PROJECT REVIEW

1. CASE 26.005, 126 BENEVOLENT STREET, Vacant Lot (POWER-COOKE)

September 21, 2026

Per the requirements of the Historic District Commission's Standards and Guidelines for Final Review, the following is a summary of design changes made since Conceptual Design Approval was granted on March 23, 2026.

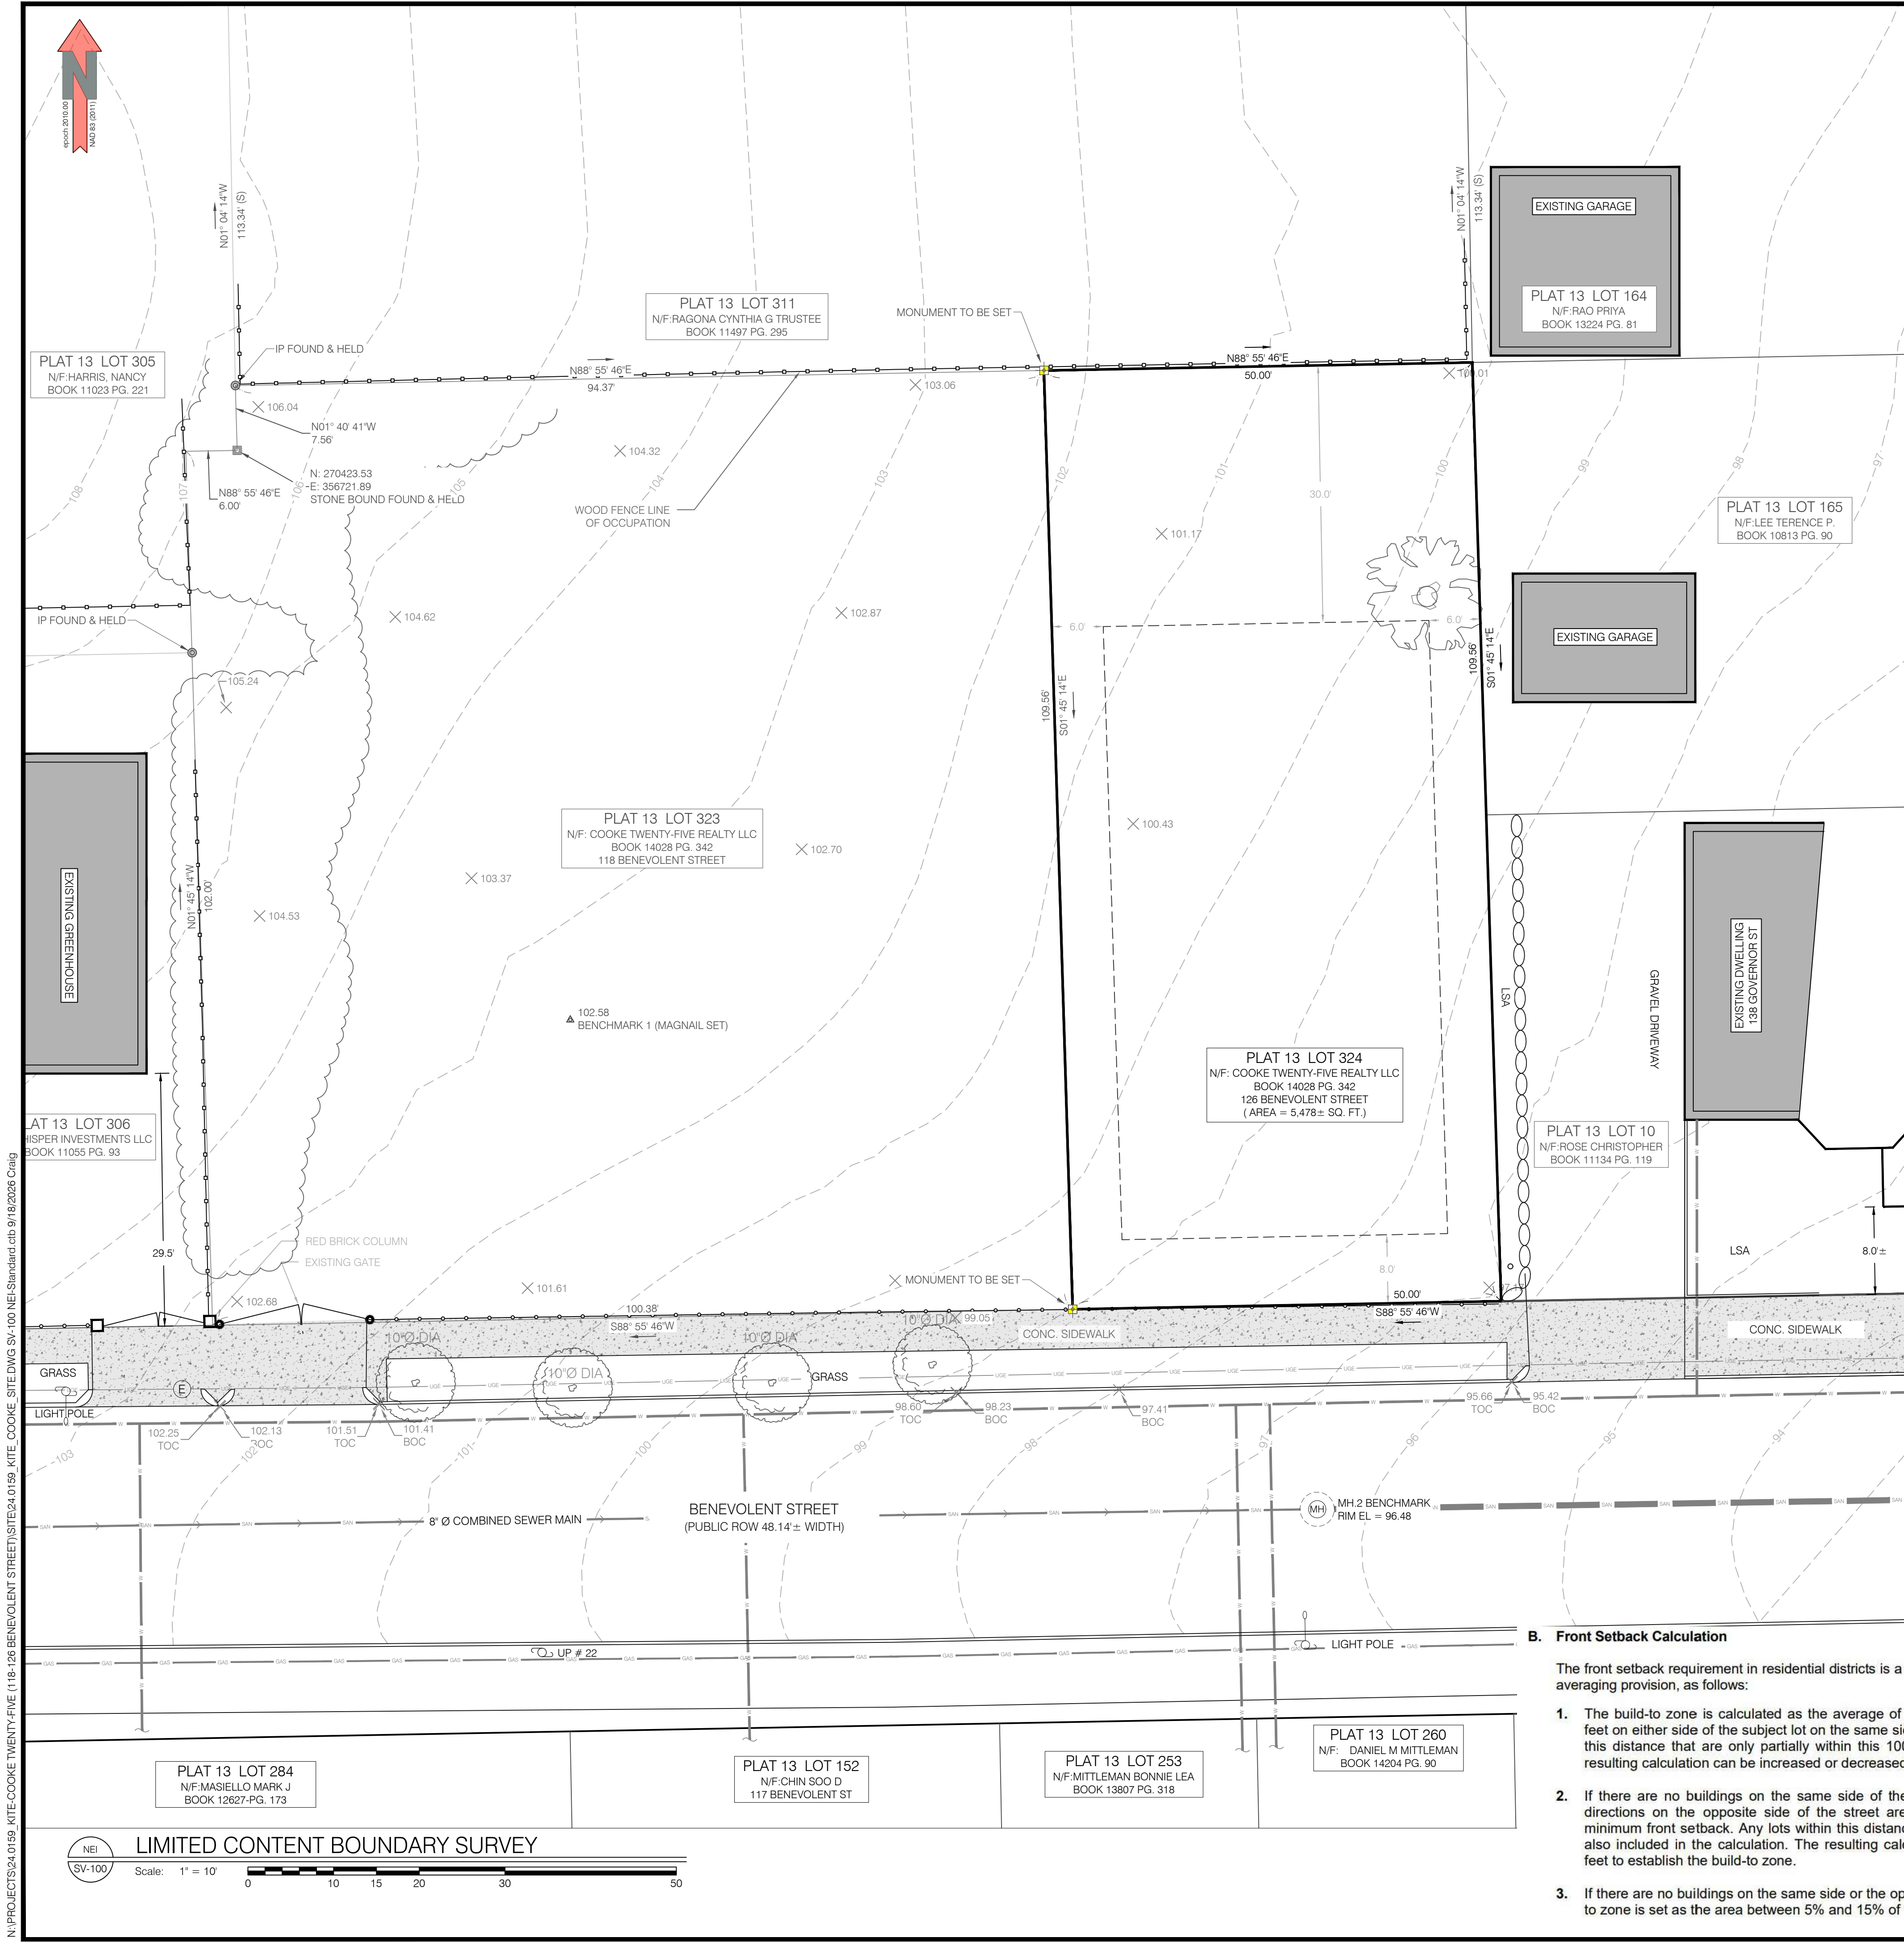
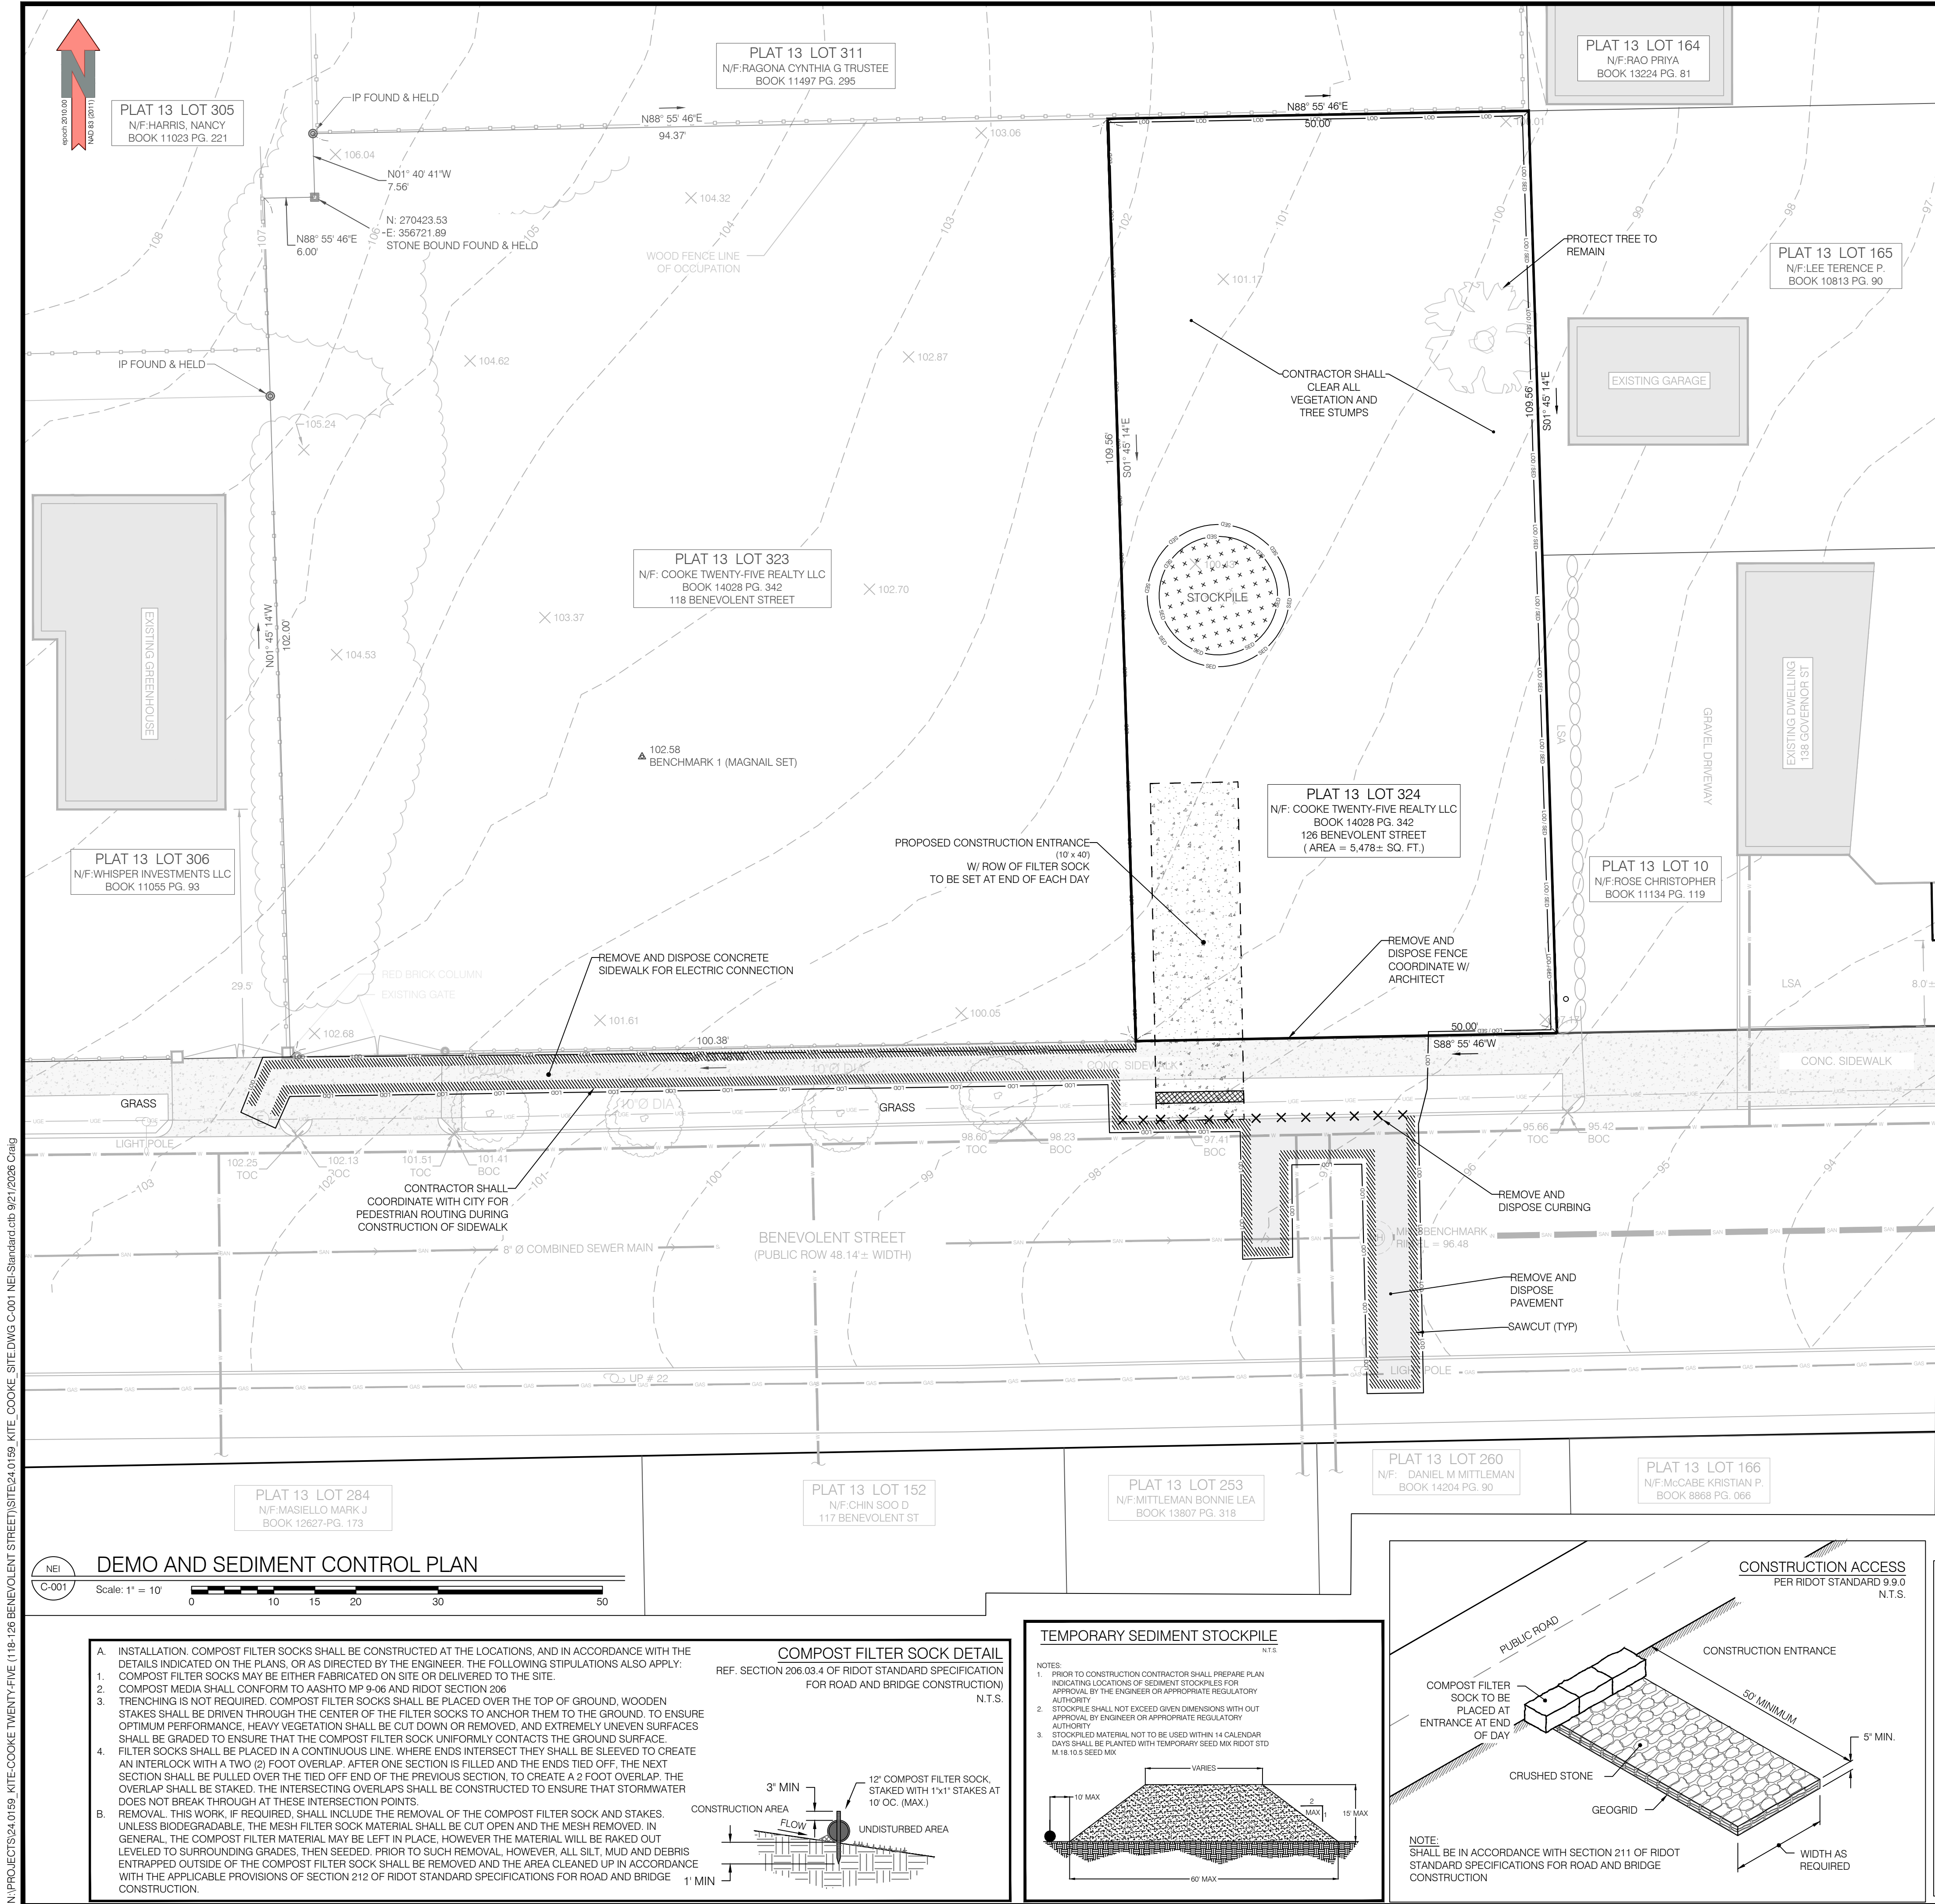
6. Transom windows above the multiglide door on the north façade have been deleted and the height of the door has been increased.
 7. Total & rear lot coverages have been adjusted to include a walkway of impervious pavers between the house and carriage house, as well as the window well. Both total and rear lot percentages continue to be within the zoning ordinance's allowances.

8. The fence along the east lot line has been adjusted to 3'-0" in height within 5'-0" of the south property line. (The remainder of the fence will be 6'-0".) All dimensions shall be taken from finish grade.

9. A civil engineer has provided a design for site drainage/regrading. Minor changes to planting locations have been made to accommodate the civil engineering.

BASEMENT FLOOR
PLAN

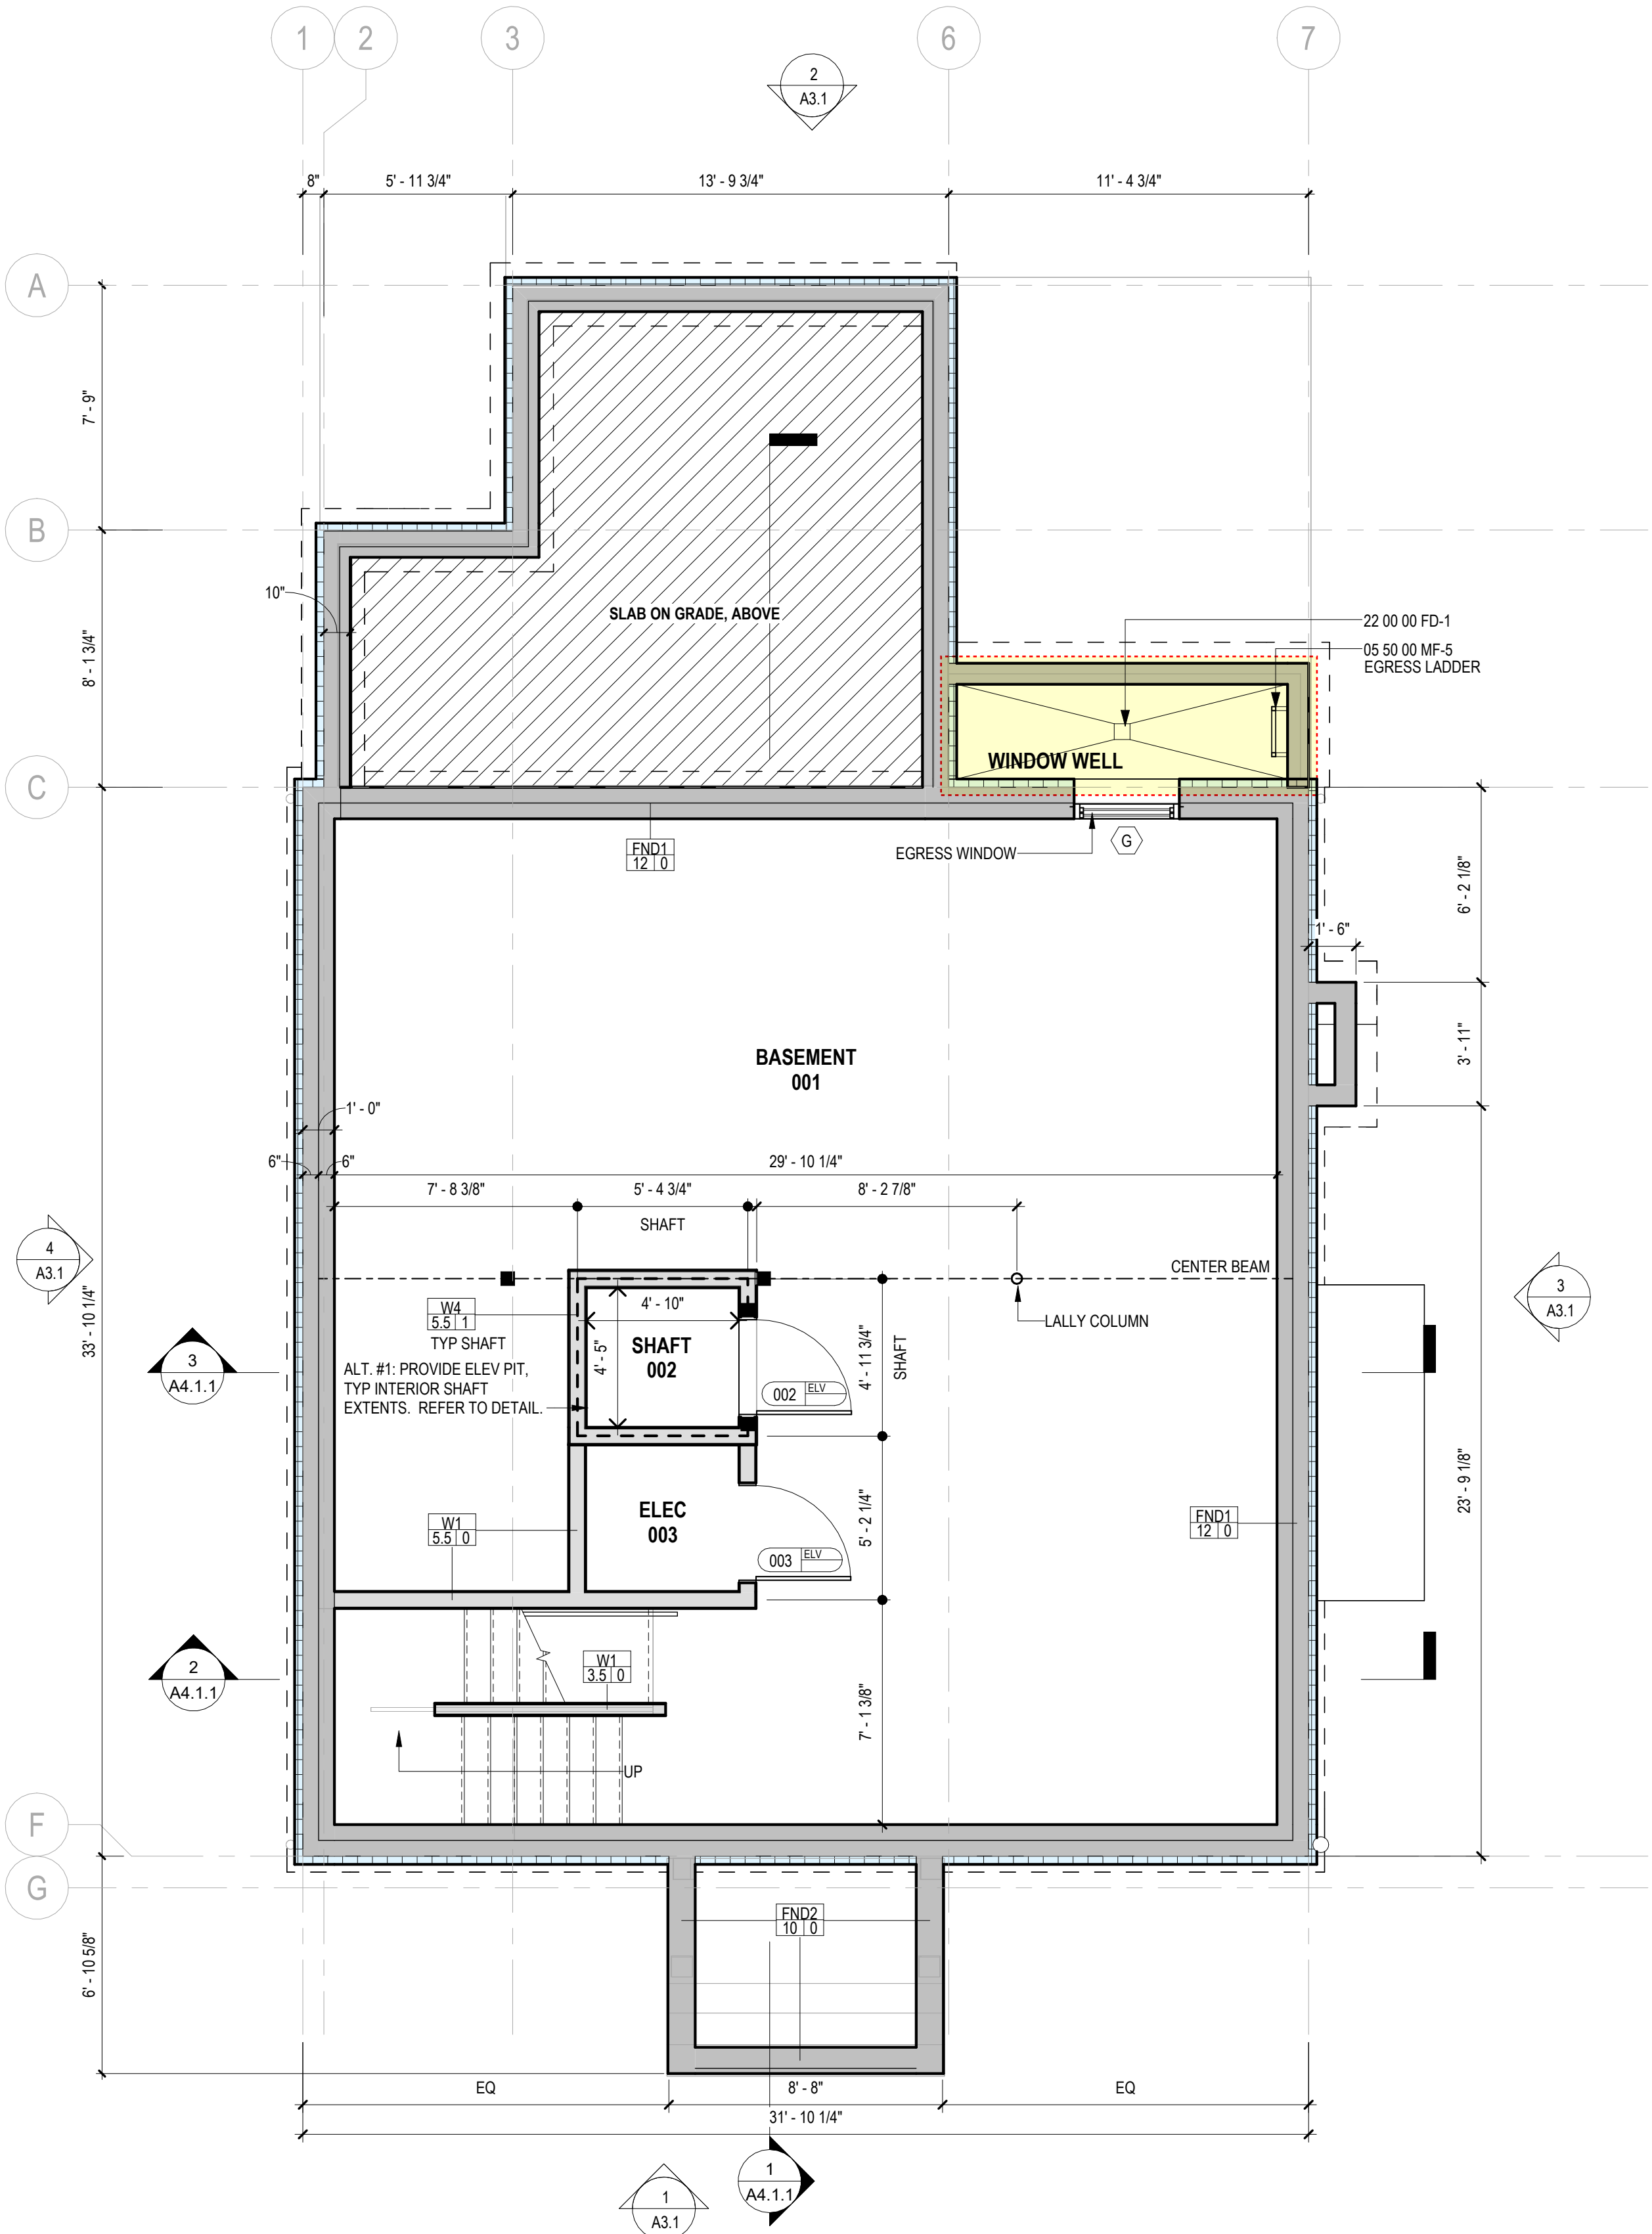
4. A third-floor window has been added to the west elevation.
 5. A basement egress window has been added to accommodate code-required egress from the basement. The window is located at the north façade, below grade level at the patio. A window well, covered by a steel grate flush with the patio surface, will be provided.
